**CIVIL ENGINEERING DEVELOPMENT APPLICATION REPORT
RESPONSE TO SARA RFI**

SARA reference no: 2602-50776 SRA
Council reference no: CA 2025_5878/1

PROPOSED RESORT DEVELOPMENT

18 OASIS DRIVE, WONGA BEACH, QUEENSLAND

Title:
SITE EARTHWORKS
CUT & FILL

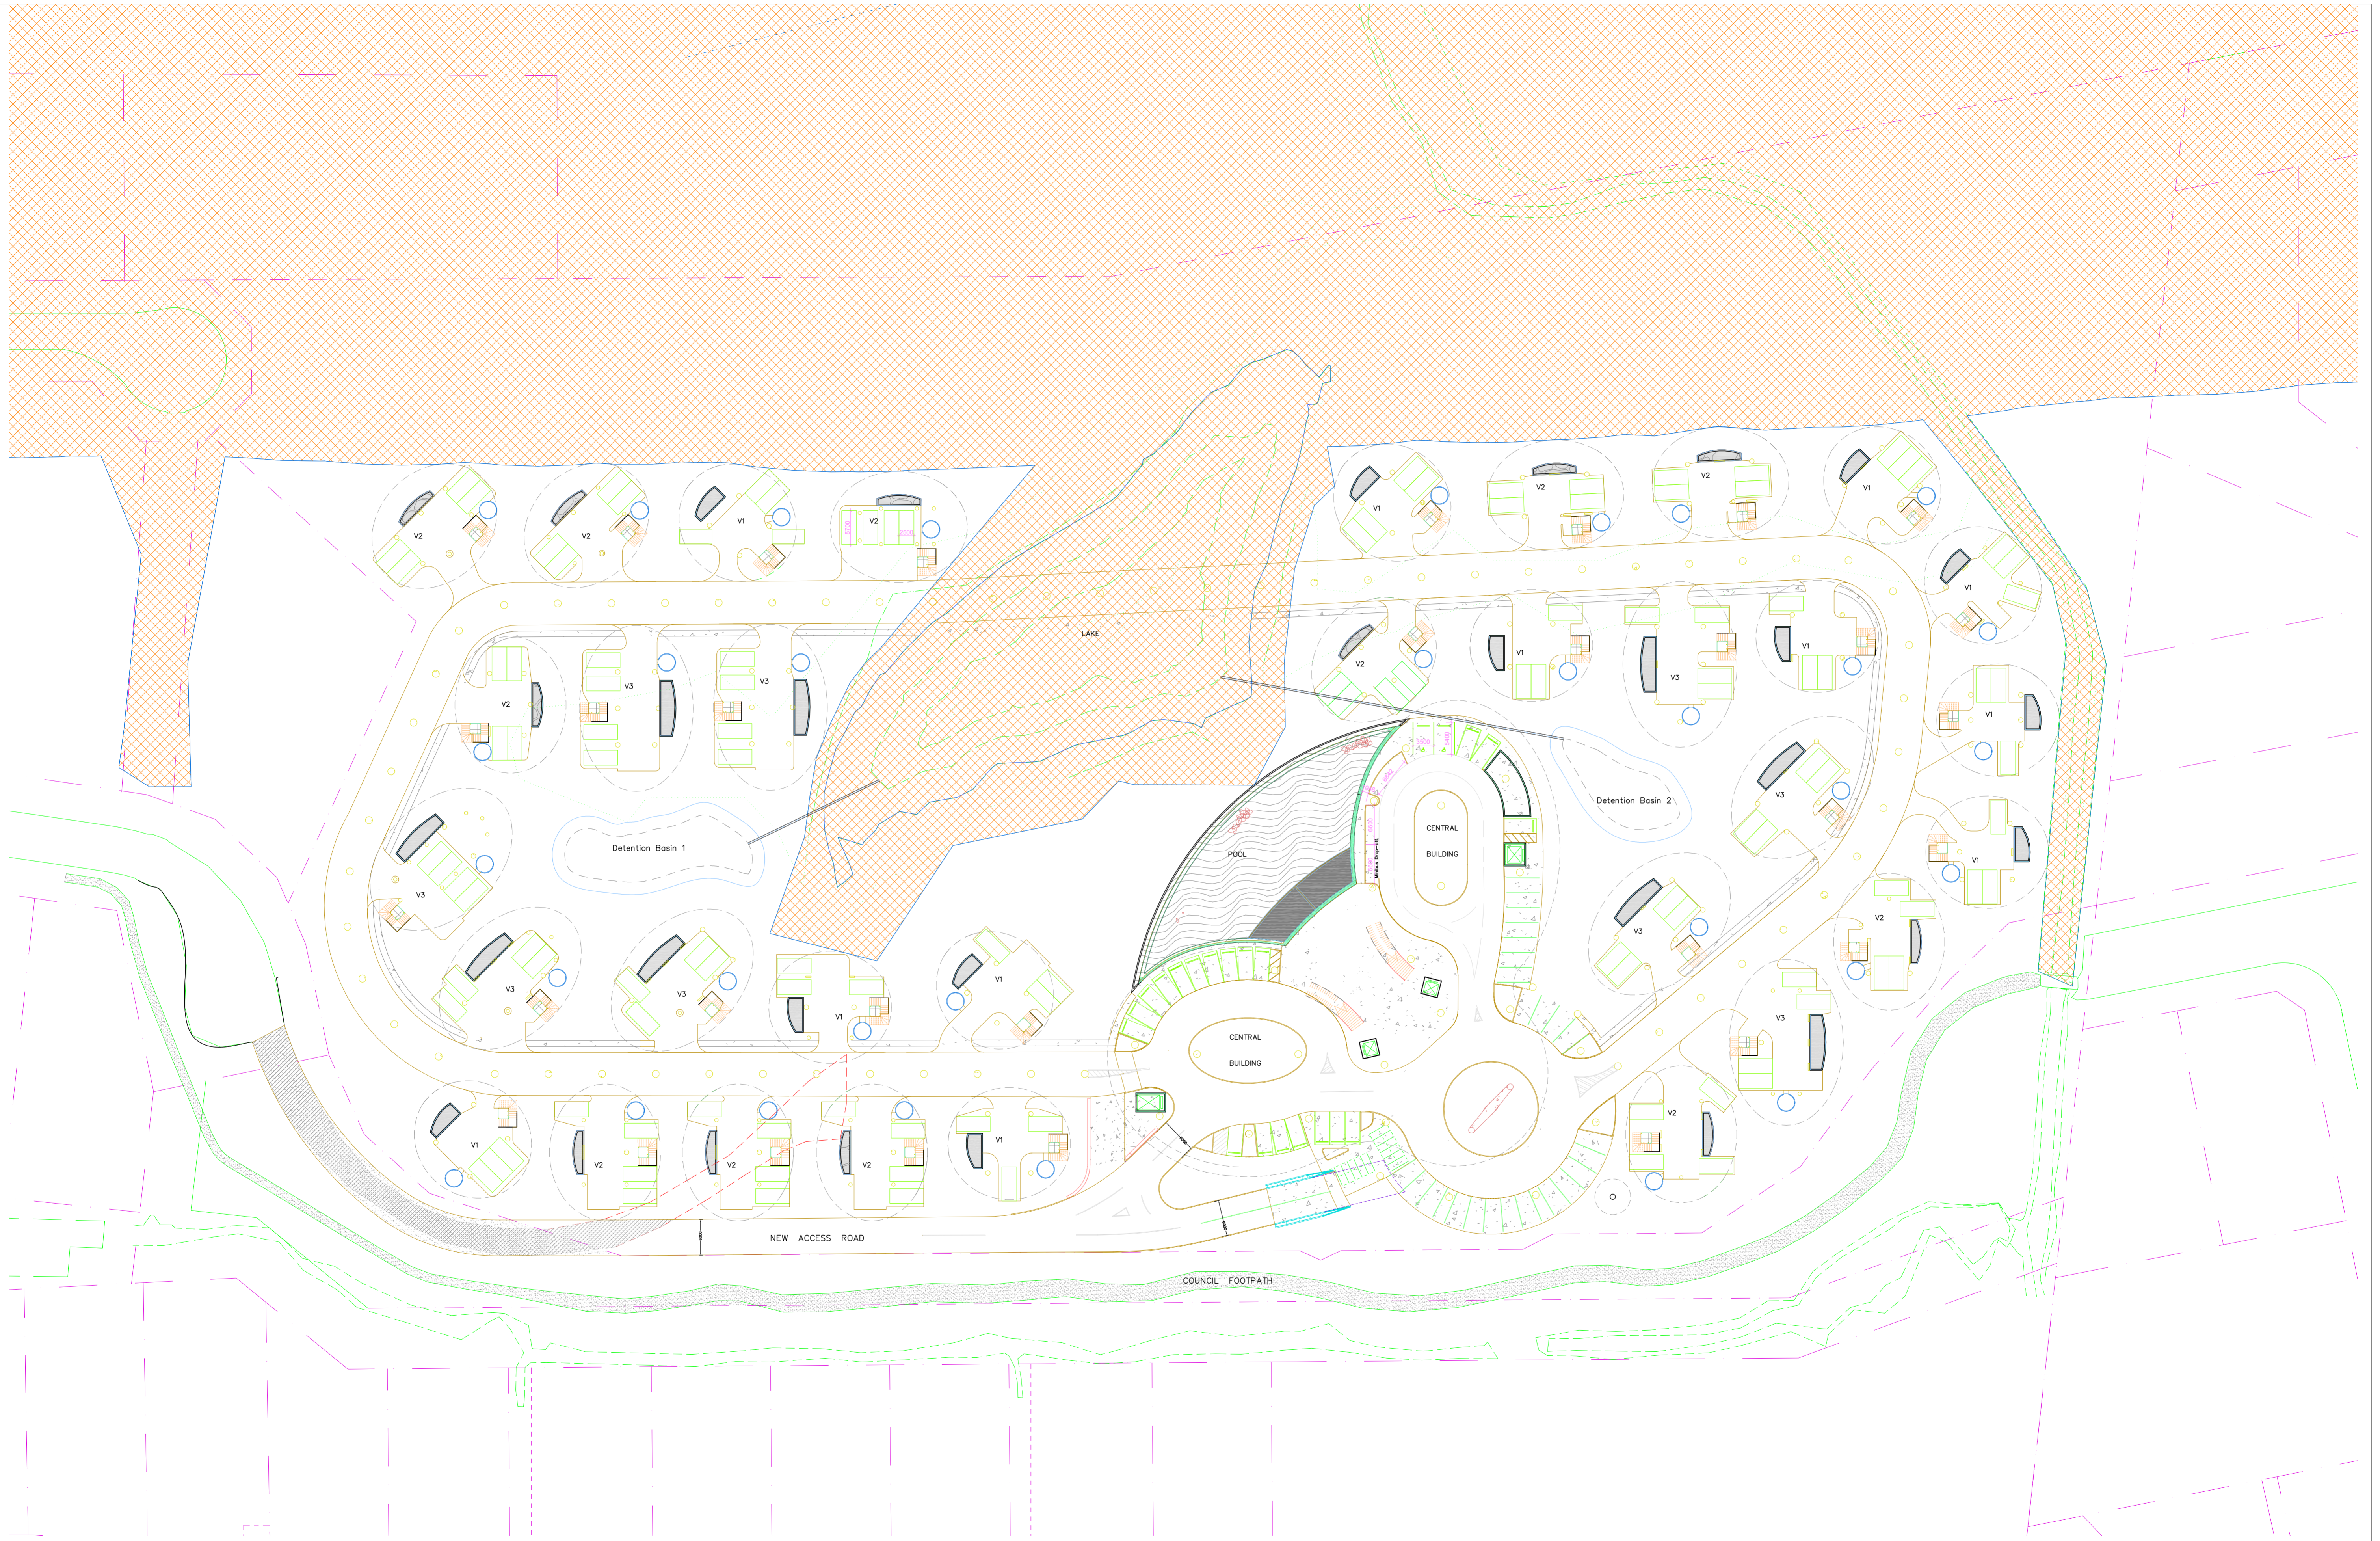
1. Associated Earthworks

The earthworks plan is attached. See drawing CO2 in appendix A

Approximately 21 of the villas require some fill to bring the parking above the flood / storm surge level. The northern end of the site requires up to 650 mm of fill, with an average closer to 450 mm. The south-eastern portion of the site requires little fill, as does the central building.

The largest excavations on the site are for the two detention basins. These are relatively shallow, with a maximum cut depth of approximately 750 mm.

There is very little cut required for the project. Approximately six of the villas, and two very small sections of two others, require cutting the ground by an average of 75-300 mm, with a maximum cut of approximately 400 mm.

Title:
Bus Turning Circles
14.5 m Rigid Bus
Undercroft Level

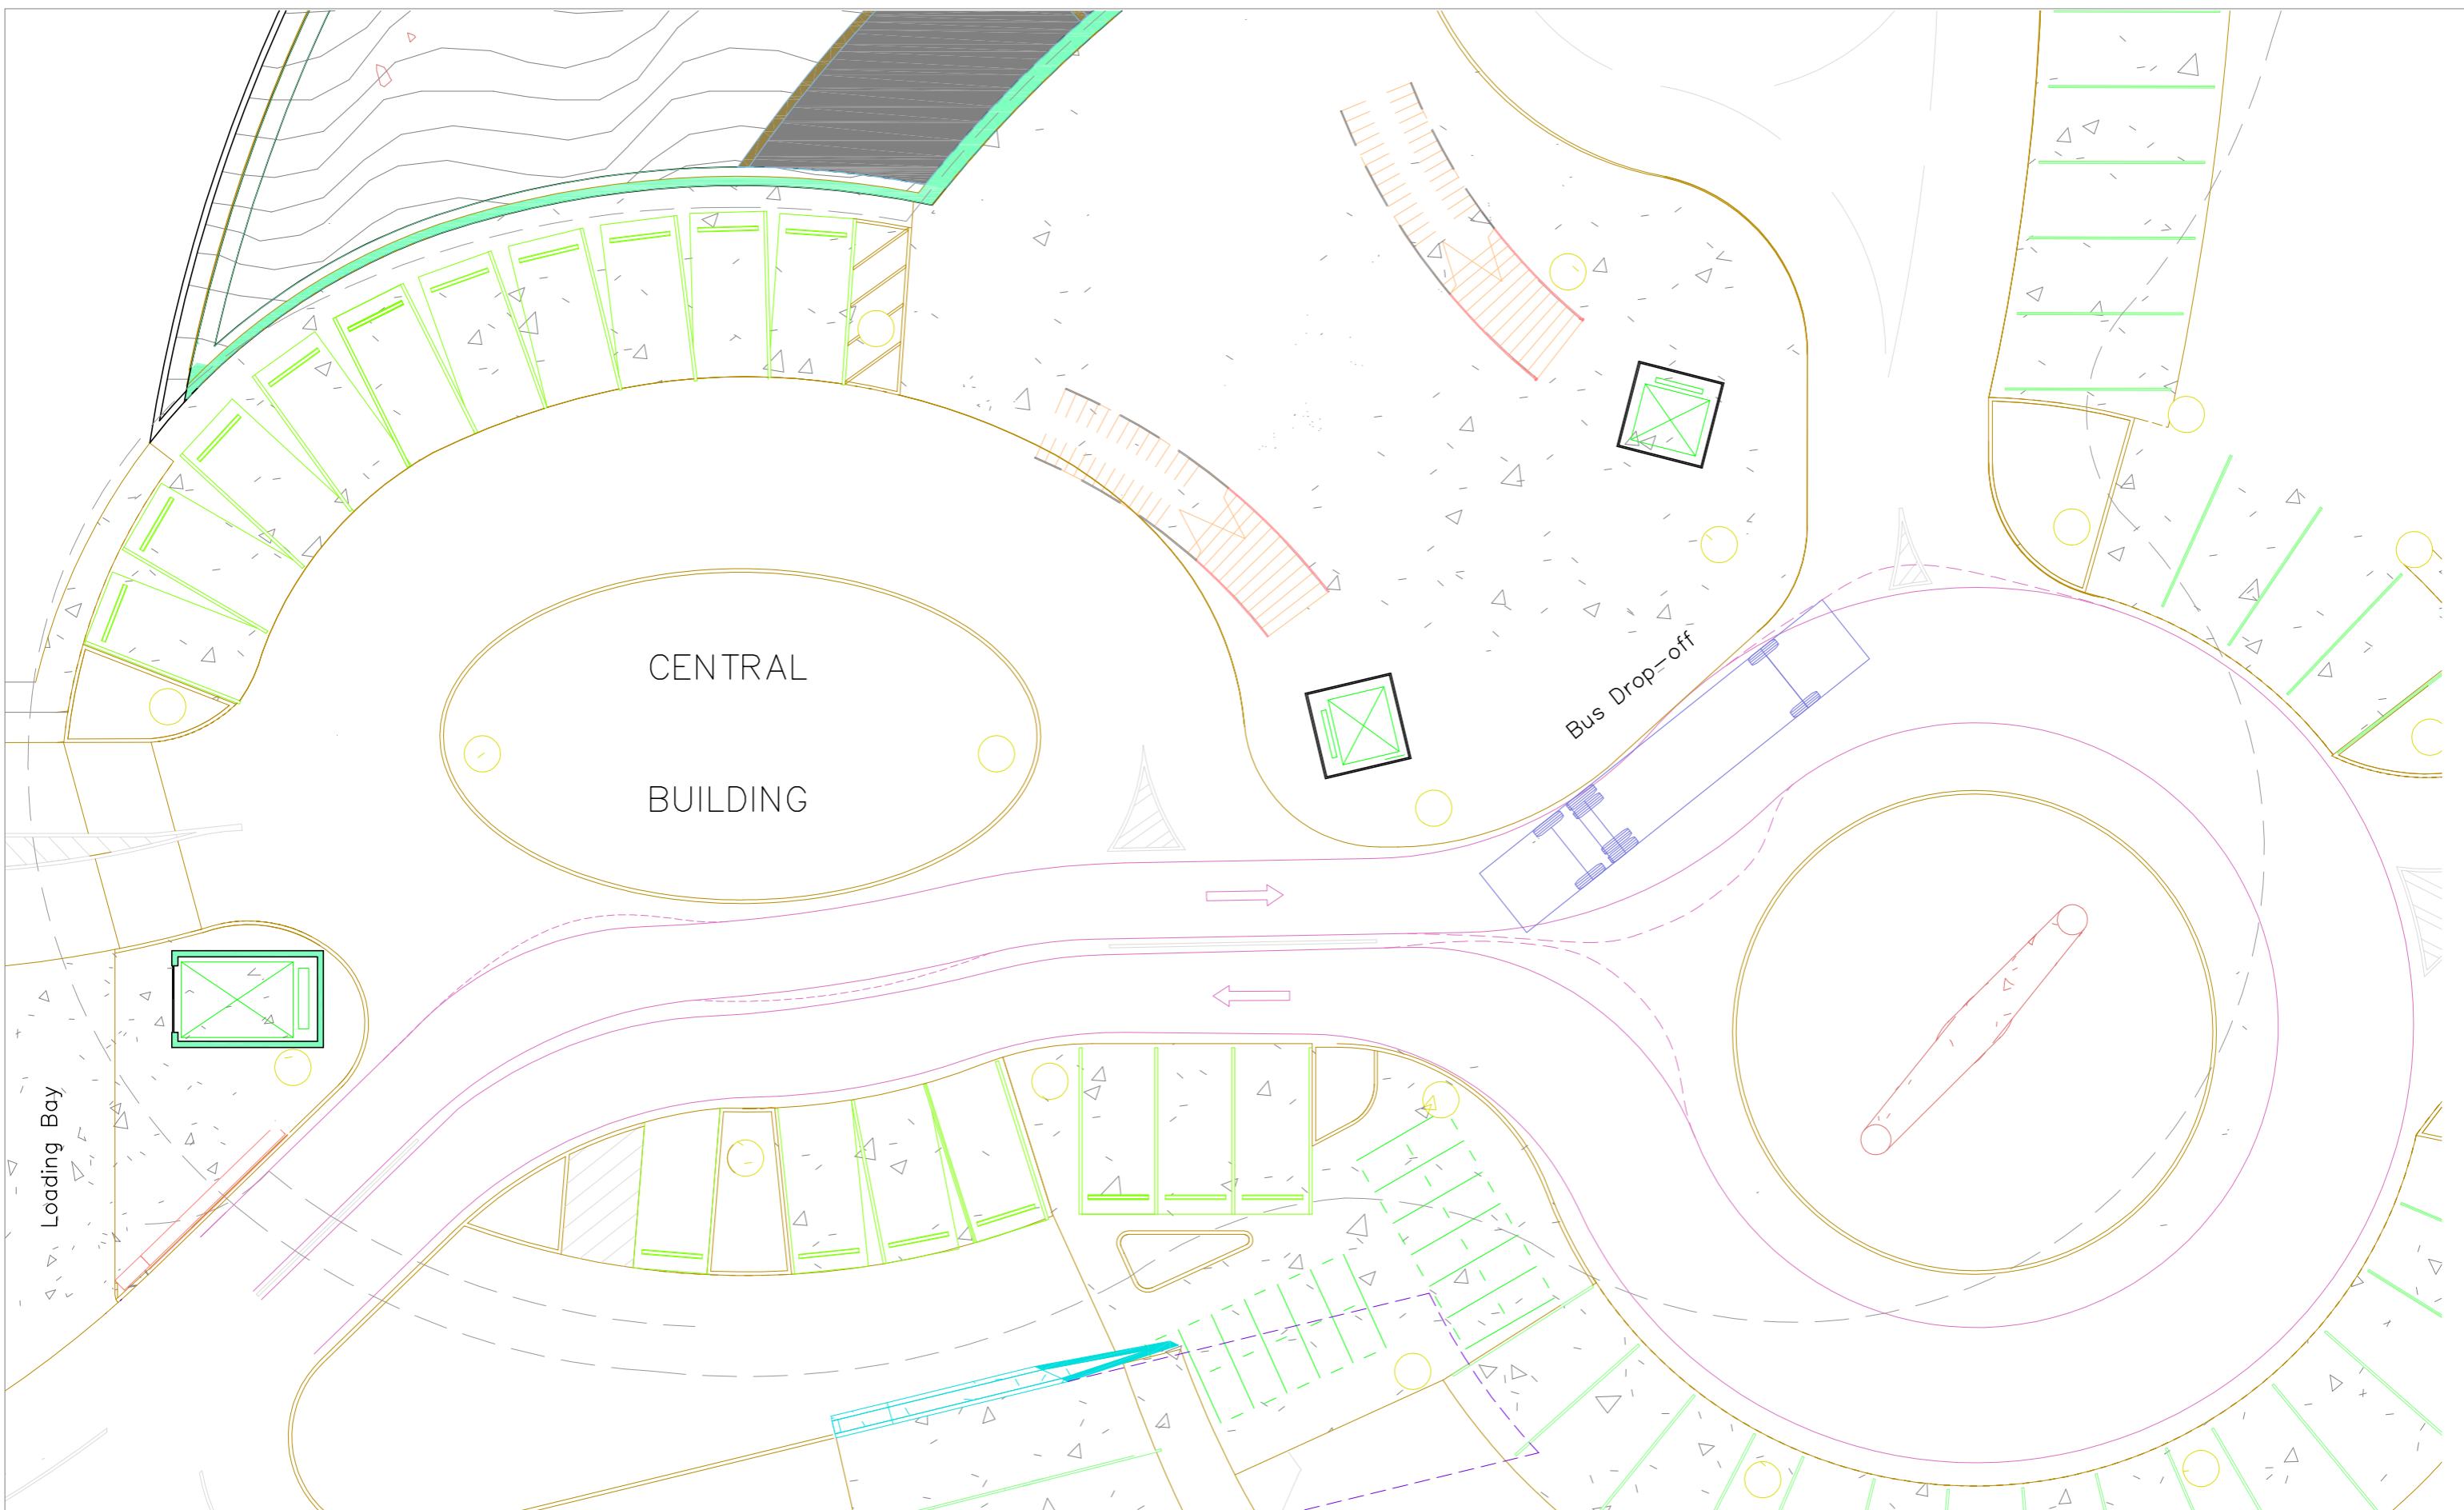
3. **Public Passenger transport – private bus set-down:**

Circulation is adequate at both levels. See the attached drawing TC01 & TC02 in appendix C. Both of these allow for smaller vehicle movement past a parked bus.

There is a dedicated loading bay at Undercroft level, adequate for a medium rigid truck. This is off the main circulation route, beside a dedicated service elevator.
